City of Mississauga Department Comments

Date Finalized: 2022-05-11 File(s): A569.21

The applicant requests the Committee to approve a minor variance to allow the construction of a widened driveway with a driveway width of 6.75m (approx. 22.15ft) whereas By-law 0225-2007, as amended, permits a maximum driveway width of 6.00m (approx. 19.7ft) in this instance.

Property Address: 7262 Sandhurst Drive

Appendix 1 – Transportation and Works Comments

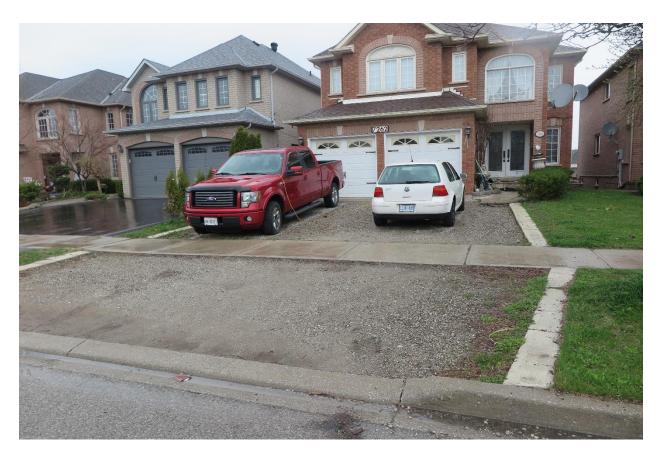
This department notes that with regard to the widened driveway within the municipal boulevard (the area between the municipal curb and property line) we would request that this area be reinstated with topsoil and sod should the application be modified to reflect a smaller driveway width within the subject property or if the application is not supported by the Committee.
